Anacapa Residence Hall Fire Safety and Renewal,
Bldg 547
Project No. FM130245L/988650
Addendum No. 2

Enclosed is **ADDENDUM NO. 2** to the Construction Documents on the above-captioned project.

ADDENDUM NO. 2

AD
 2.01

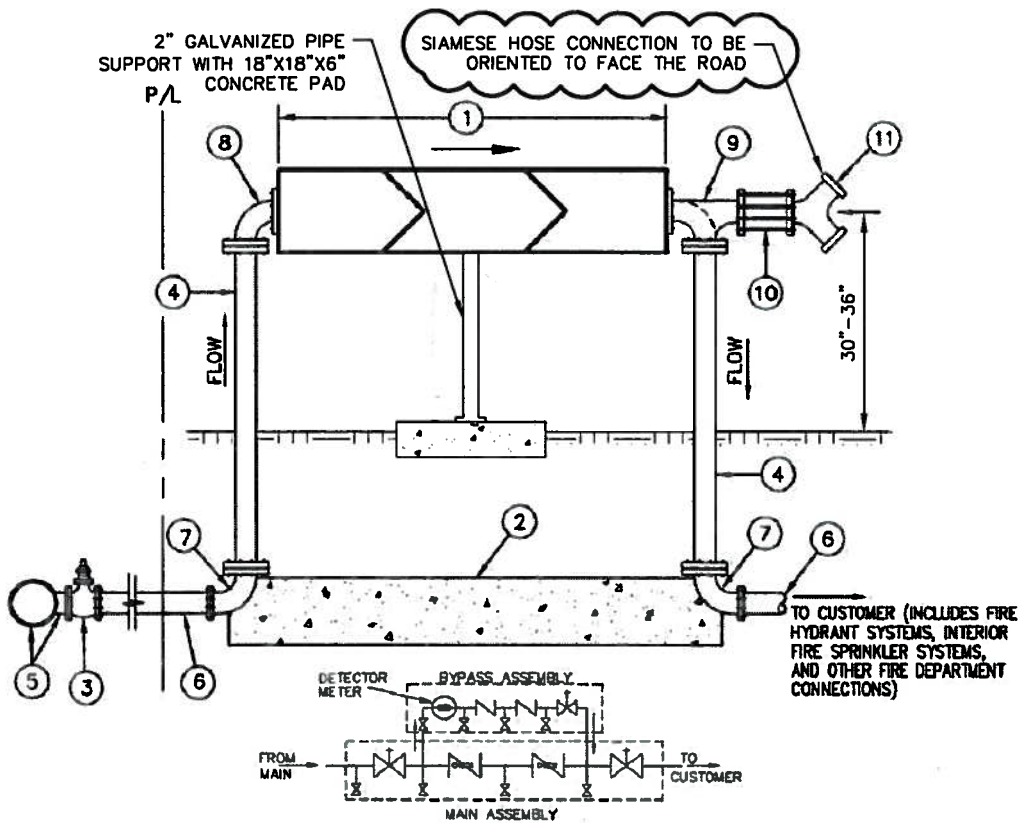
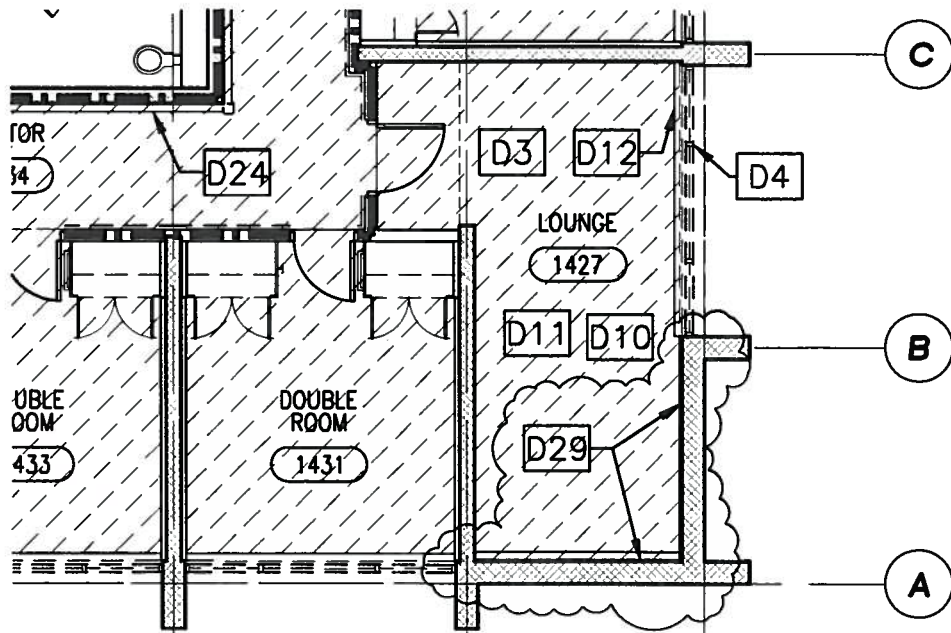
1. SHEET T200 2nd Floor Code Plan – Existing Conditions:
 - a. **REVISE** Room 2227 to read “Double Room.”
 - b. **REVISE** Room 2427 to read “Storage.”
2. CIVIL SHEET C300 Detail 1: REVISE per attached drawing AD2.01.
3. ARCHITECTURAL SHEET A102 Overall Key Plan/ Floor Plan – 2nd Floor:
 - a. **REVISE** Room 2227 to read “Double Room.”
 - b. **REVISE** Room 2427 to read “Storage.”
4. ARCHITECTURAL SHEET D200:
 - a. Keynotes: **ADD** Keynote 29 as follows:

DCDA AND FDC CONNECTION

UCSB DWG #	AD
547-114	
DATE	2.02
04/10/13

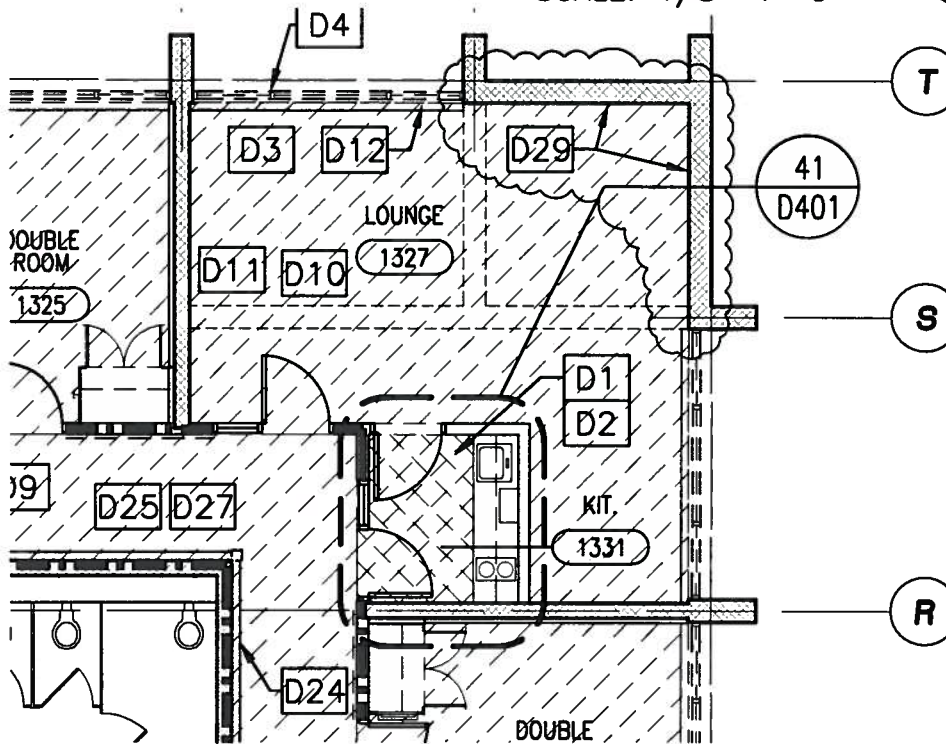
- a. Floor Plan- Lounge 1327 & Lounge 1427: **REVISE** per attached drawing AD2.02.

D29 REMOVE (E) TACKABLE WALL SYSTEM, FIBERBOARD AND FABRIC, SEE 32/D400 SIM.

UCSB DWG # 547-114	AD
DATE 04/10/13	2.03

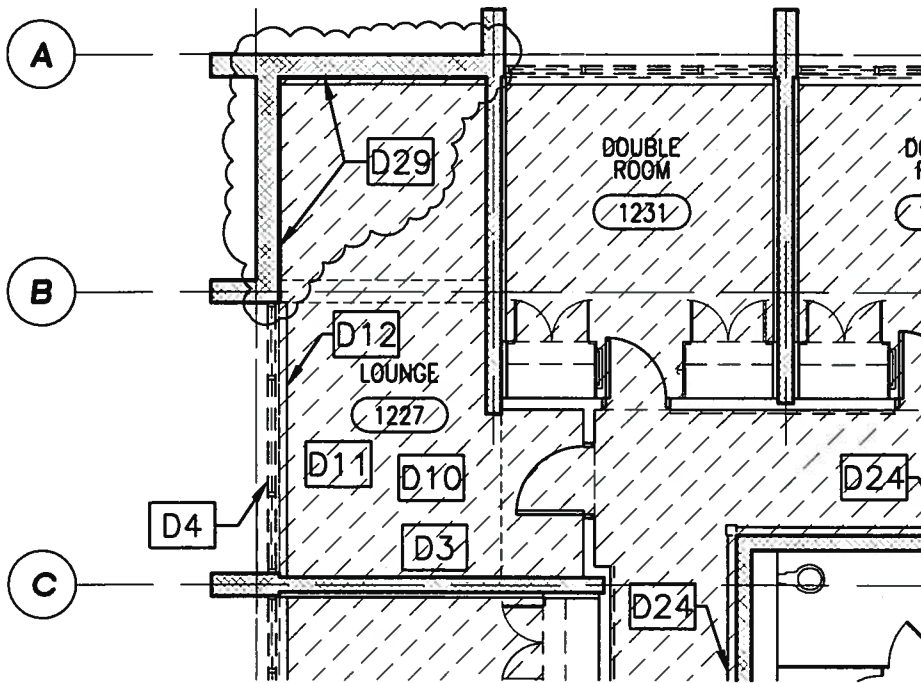
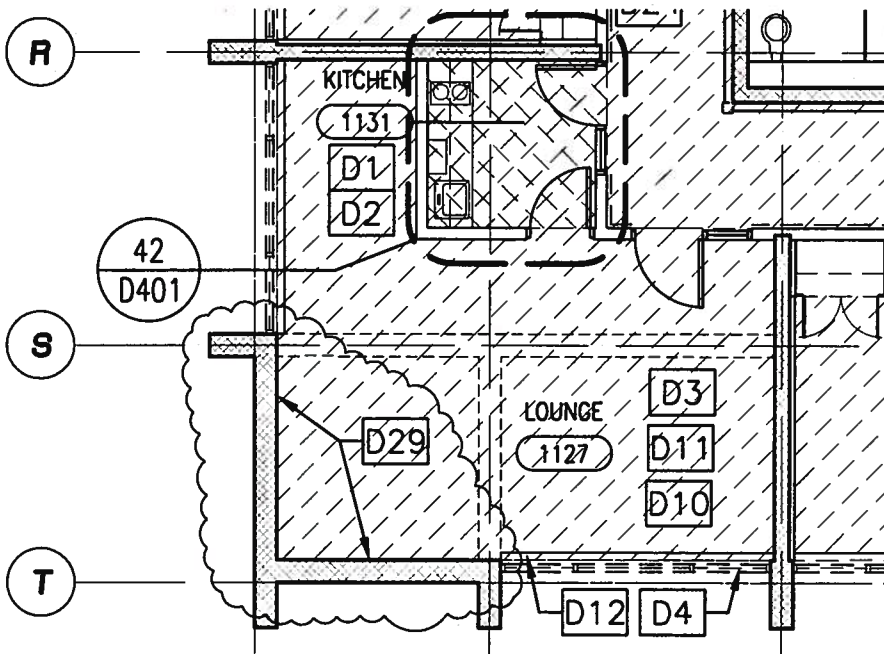
c. Floor Plan- Lounge 1127 & Lounge 1227: **REVISE** per attached drawing AD2.03.

D29 REMOVE (E) TACKABLE WALL SYSTEM, FIBERBOARD AND FABRIC, SEE 32/D400 SIM.

UCSB DWG # 547-114	AD
DATE 04/10/13	2.04

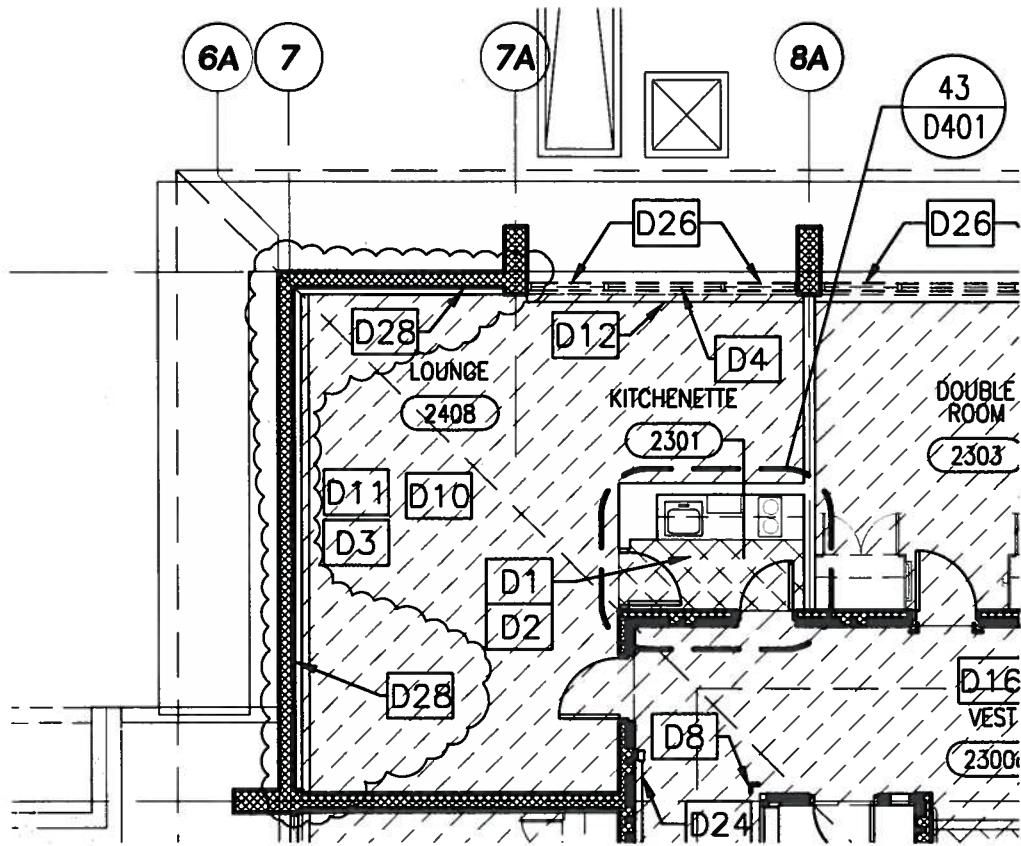
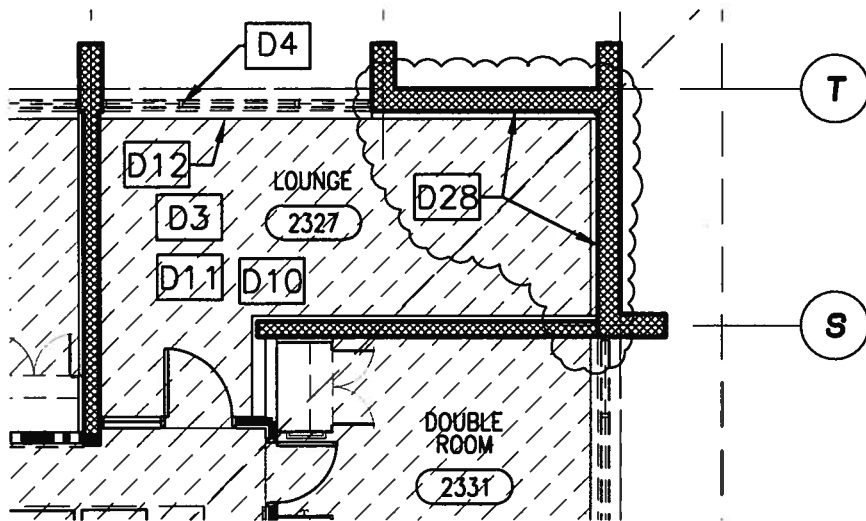
c. Floor Plan- Lounge 2327 & Lounge 2408: **REVISE** per attached

drawing AD2.04.

D28 REMOVE (E) TACKABLE WALL SYSTEMS, FIBERBOARD AND FABRIC, SEE 32/D400 SIM.

AD
2.05

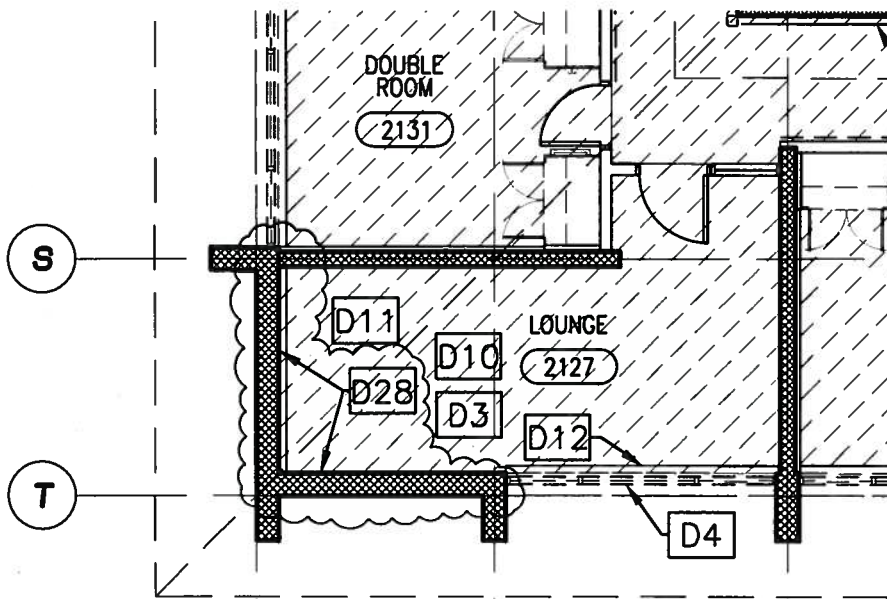
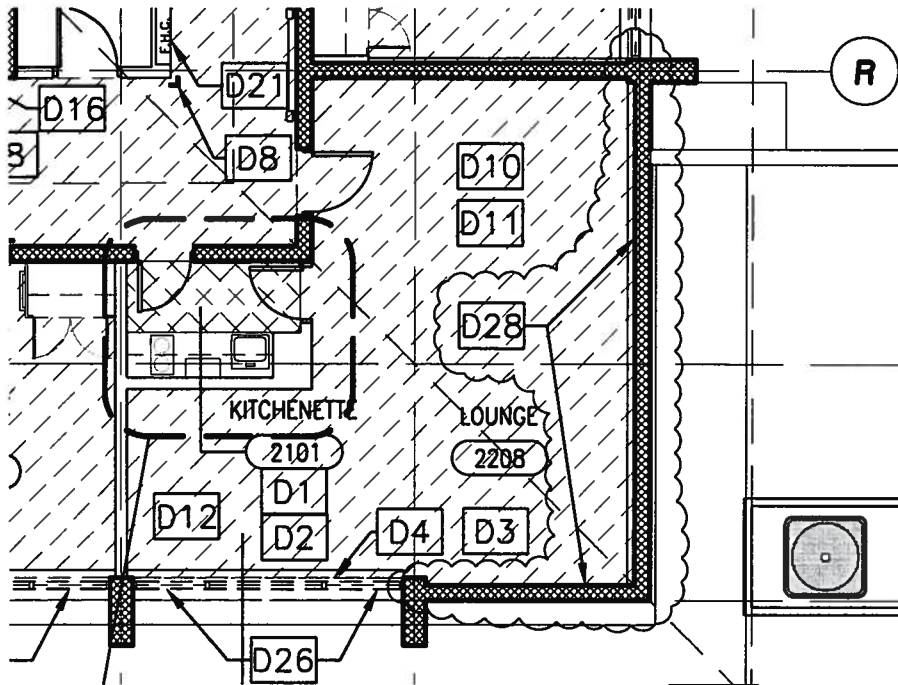
c. Floor Plan- Lounge 2127 & Lounge 2208: **REVISE** per attached drawing AD2.05.

D28 REMOVE (E) TACKABLE WALL SYSTEMS, FIBERBOARD AND FABRIC, SEE 32/D400 SIM.

UCSB DWG #	AD
547-114	
DATE	2.06
04/10/13

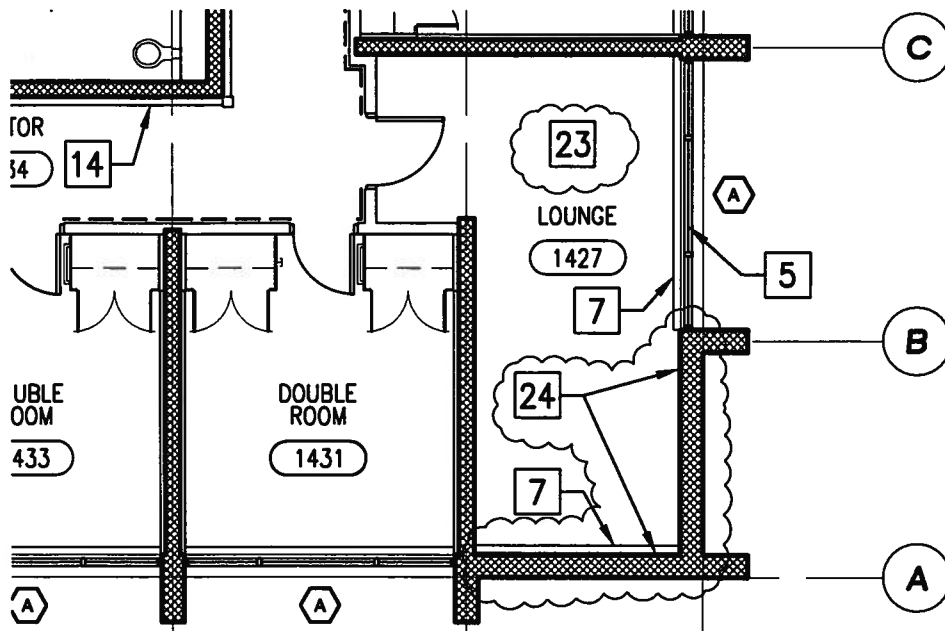
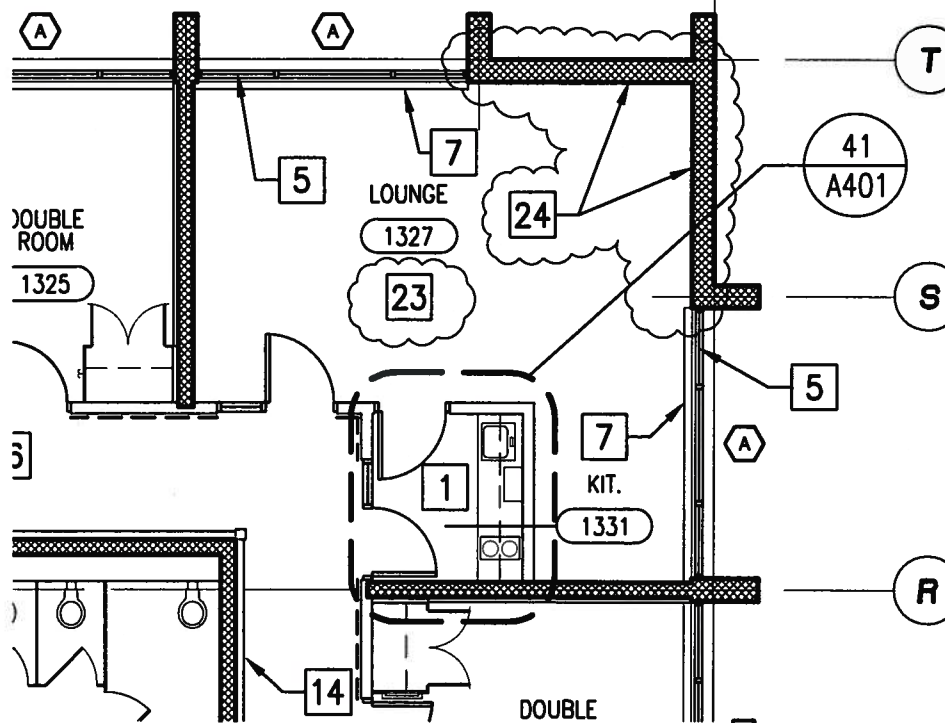
b. Floor Plan – Lounge 1327 and Lounge 1427: **REVISE** per attached drawing AD2.06.

23 WINDOW COVERINGS AND TRACKS, FURNISHED AND INSTALLED BY OTHERS

24 INSTALL NEW TACKABLE WALL SYSTEM PER SPECIFICATION 09772, INCLUDING NEW FRAME, CORE MATERIAL AND FABRIC AFTER REMOVAL OF (E) TACKABLE WALL PANELS, SEE 23/A400 FOR SIMILAR INSTALLATION

UCSB DWG # 547-114	AD
DATE 04/10/13	2.07

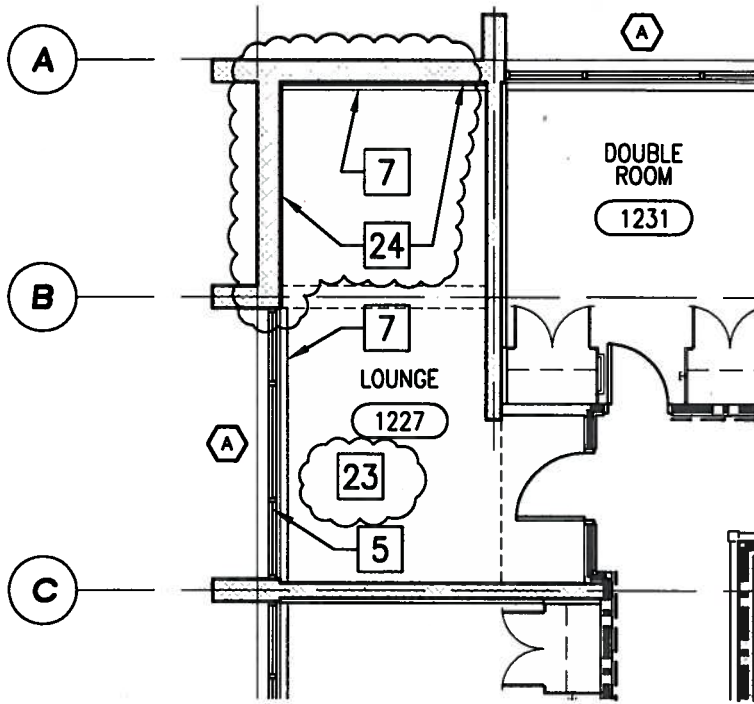
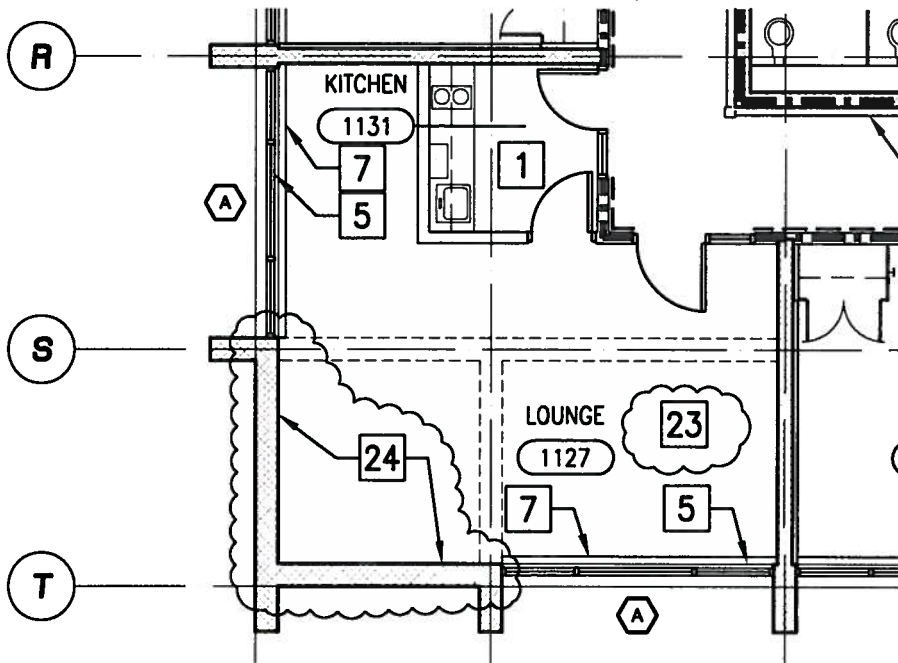
1. Lounge 1127 and Lounge 1227: **REVISE** per attached drawing AD2.07.
2. Double Room 1241: **ADD** Window type “A” symbol to exterior window.

23 WINDOW COVERINGS AND TRACKS, FURNISHED AND INSTALLED BY OTHERS SCALE: 1/8"=1'-0"

24 INSTALL NEW TACKABLE WALL SYSTEM PER SPECIFICATION 09772, INCLUDING NEW FRAME, CORE MATERIAL AND FABRIC AFTER REMOVAL OF (E) TACKABLE WALL PANELS, SEE 23/A400 FOR SIMILAR INSTALLATION

UCSB DWG #	AD
547-114	
DATE	2.08
04/10/13

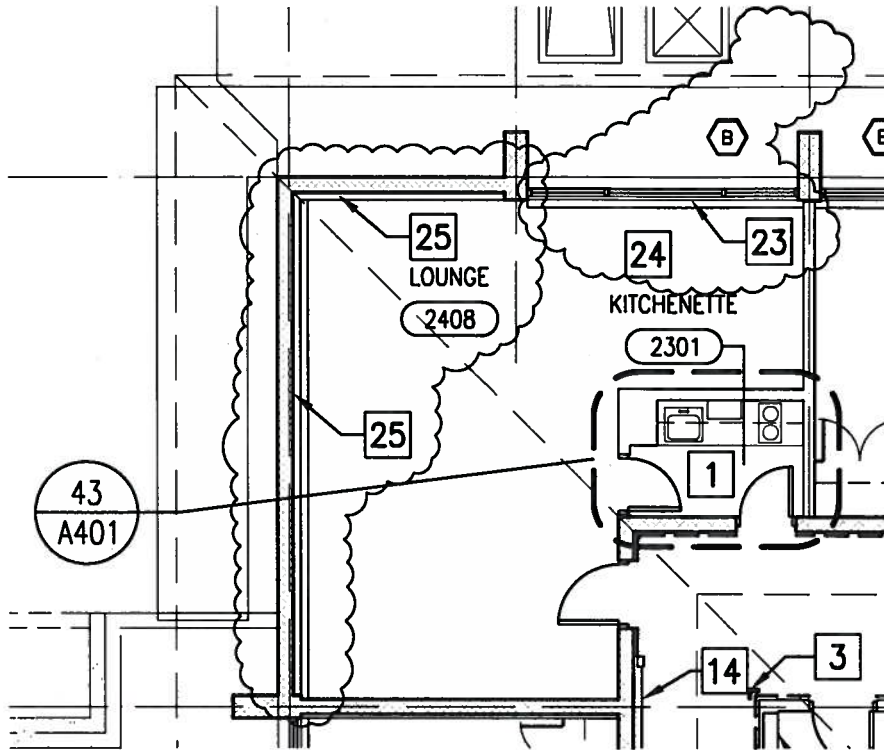
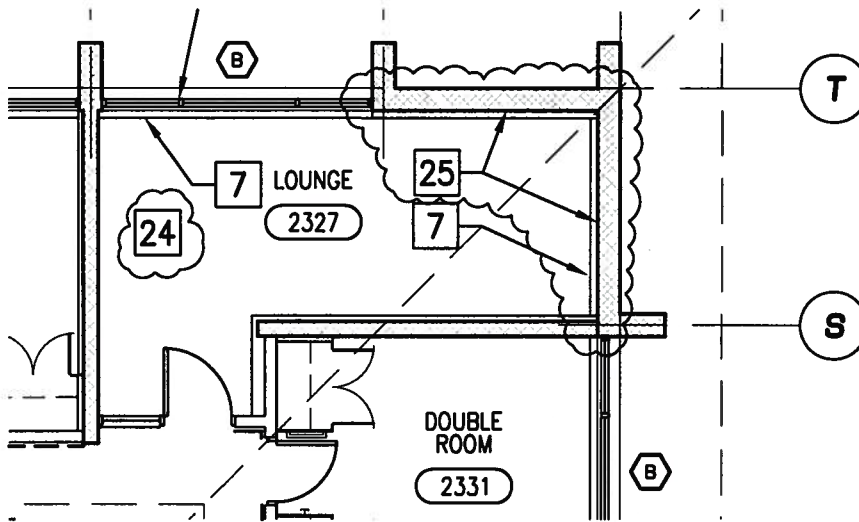
b. Floor Plan – Lounge 2408

1. **REVISE** Keynote “5” to be Keynote “23”

2. **REMOVE** Keynote “2” and “20”

3. **REVISE** per attached drawing AD2.08.

c. Floor Plan-Lounge 2327

1. **REVISE** per attached drawing AD2.08.

- 23** PROVIDE NEW ALUMINUM WINDOW WITH TWO (2) SECURITY SCREENS IN LIEU OF GLASS FIBER MESH WINDOW SCREENS, SEE A500 WINDOW SCHEDULE AND DETAILS 41,42, & 43/A602
- 24** WINDOW COVERINGS AND TRACKS FURNISHED AND INSTALLED BY OTHERS
- 25** INSTALL NEW TACKABLE WALL SYSTEM PER SPECIFICATION 09772, INCLUDING NEW FRAME, CORE MATERIAL AND FABRIC AFTER REMOVAL OF (E) TACKABLE WALL PANELS, SEE 23/A400 FOR SIMILAR INSTALLATION

UCSB DWG # 547-114	AD
DATE 04/10/13	2.09

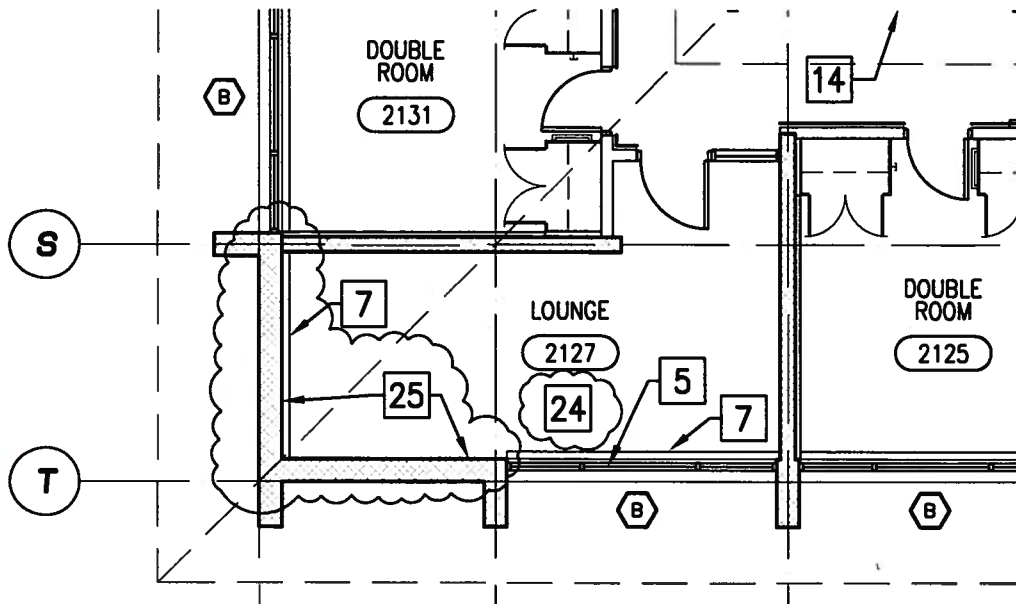
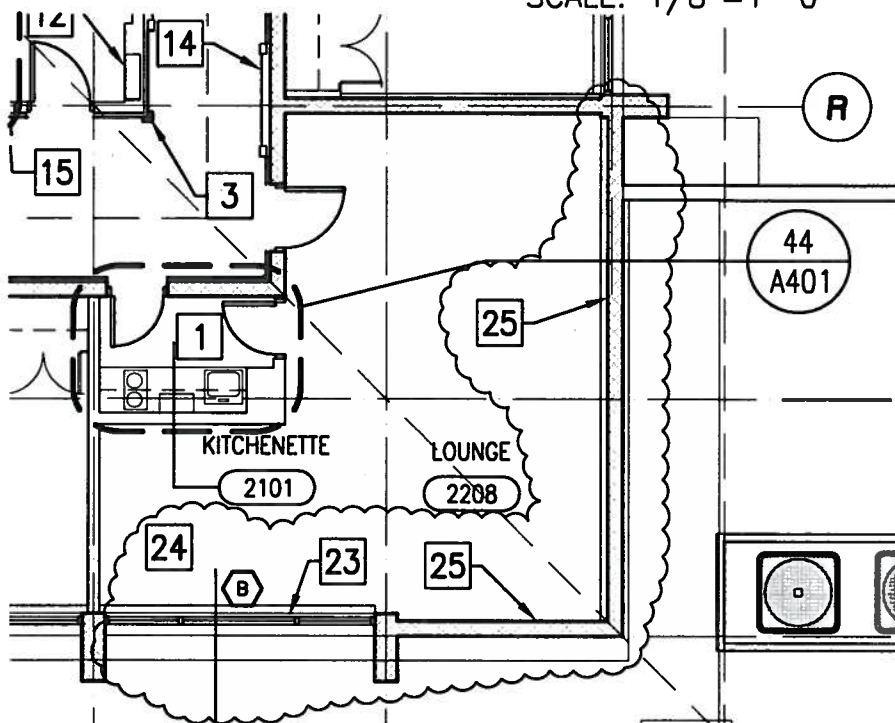
b. Floor Plan – Lounge 2208

1. **REVISE** Keynote “5” to be Keynote “23”

2. **REMOVE** Keynote “20”

3. **REVISE** per attached drawing AD2.09.

c. Floor Plan-Lounge 2127

1. **REVISE** per attached drawing AD2.09.

- 23** PROVIDE NEW ALUMINUM WINDOW WITH TWO (2) SECURITY SCREENS IN LIEU OF GLASS FIBER MESH WINDOW SCREENS, SEE A500 WINDOW SCHEDULE AND DETAILS 41,42, & 43/A602
- 24** WINDOW COVERINGS AND TRACKS FURNISHED AND INSTALLED BY OTHERS
- 25** INSTALL NEW TACKABLE WALL SYSTEM PER SPECIFICATION 09772, INCLUDING NEW FRAME, CORE MATERIAL AND FABRIC AFTER REMOVAL OF (E) TACKABLE WALL PANELS, SEE 23/A400 FOR SIMILAR INSTALLATION
